WOLF CREEK

Subject: Docket No. 50-482: Request for Relief From ASME
Section XI Hydrostatic Testing of Class 1 and Class 2
Pressure Boundaries

INSERVICE INSPECTION RELIEF REQUEST

FIGURE 1
General RCS Pressure Isolation
Valve Pressure Boundary
Representation
(Bold lines represent boundary
subject to relief)

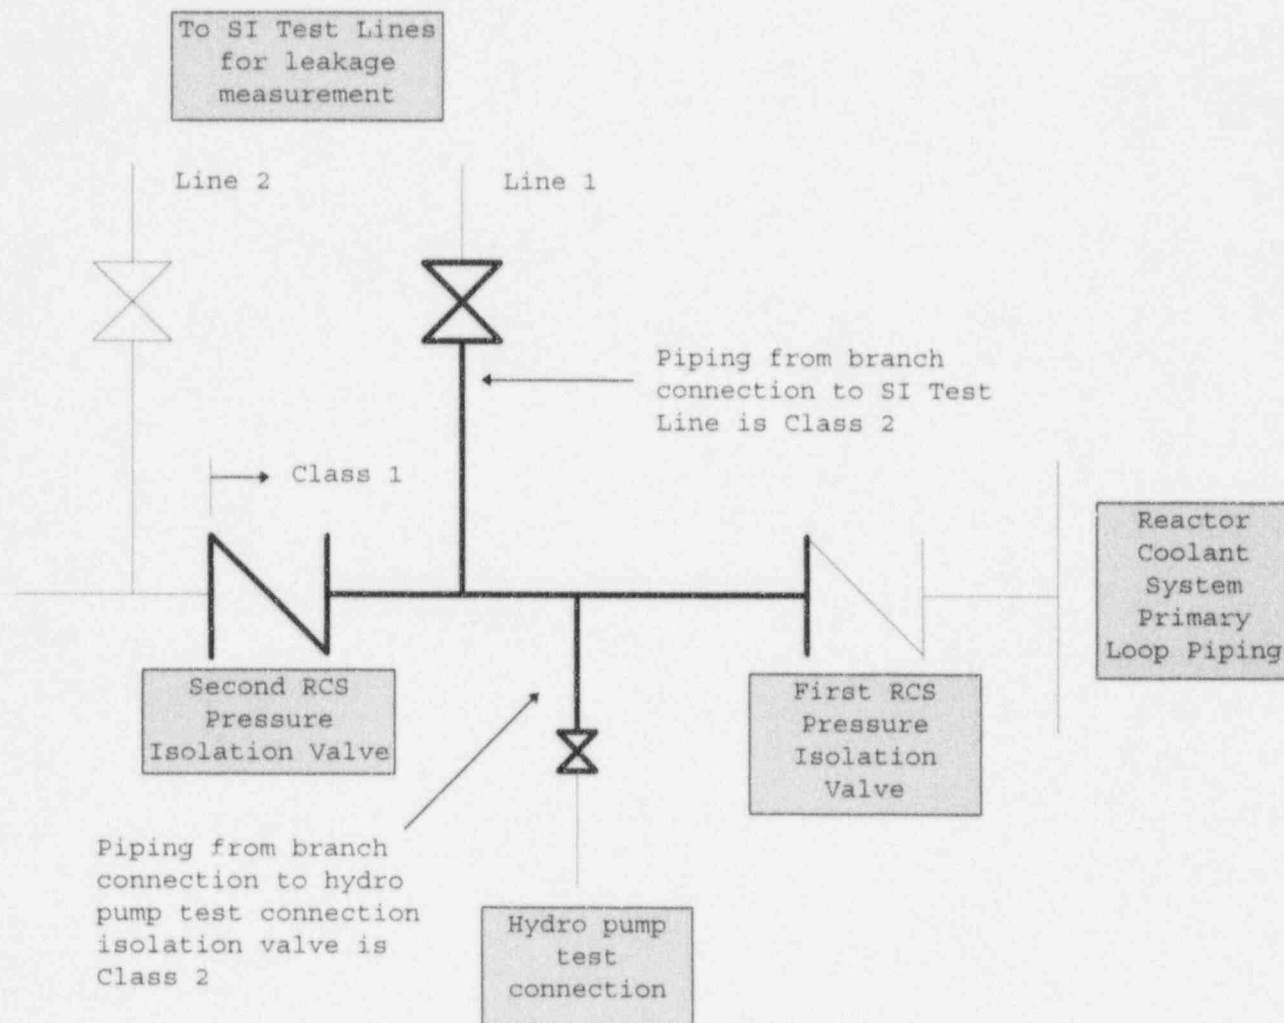
Hydrostatic testing of ASME Class 1 and Class 2 pressure boundaries between RCS Pressure Isolation Valves (subject boundaries utilize check valves). These pressure boundaries include a Class 2 piping connection from the Class 1 portion of piping to the associated Safety Injection System Test Line Isolation Valve (Reference Figure 1).

For the subject pressure boundaries verified as maintaining a pressure of at least 2000 psig (which is approximately 90% of RCS operating pressure) for the Code required hold time of 4 hours during the current fuel cycle (cycle 8), WCNOC requests relief from the First 10-Year Inservice Inspection Interval Section XI requirements for performing the 10-year system hydrostatic testing of the Class 1 and Class 2 pressure boundaries located between the RCS Pressure Isolation Valves. Relief is requested on the basis that the verification of pressure greater than 2000 psig for a minimum of four hours in combination with the inspections implemented as a result of Generic Letter 88-05 provide an alternative which provides an acceptable level of quality and safety. The implementation of a separate test to apply ASME Section XI 10-year system hydrostatic test pressure and hold time requirements to these pressure boundary locations would result in a hardship to WCNOC in the form of additional testing, financial burden and additional dose to personnel without a compensating increase in quality and safety.

For the subject pressure boundaries verified as not maintaining a pressure of at least 2000 psig for the Code required hold time of 4 hours during the current fuel cycle (cycle 8), WCNOC requests relief from the First 10-Year Inservice Inspection Interval Section XI requirements for performing the 10-year system hydrostatic testing of the Class 1 and Class 2 pressure boundaries located between the RCS Pressure Isolation Valves. Relief is requested on the basis that the combined boric acid monitoring program inspections implemented as a result of Generic Letter 88-05 and the comparison of the pressure source and leakage measurements, provide an alternative which provides an acceptable level of quality and safety. The implementation of a separate test to apply ASME Section XI 10-year system hydrostatic test pressure and hold time requirements to these pressure boundary locations would result in a hardship to WCNOC in the form of additional testing, financial burden and additional dose to personnel without a compensating increase in quality and safety.
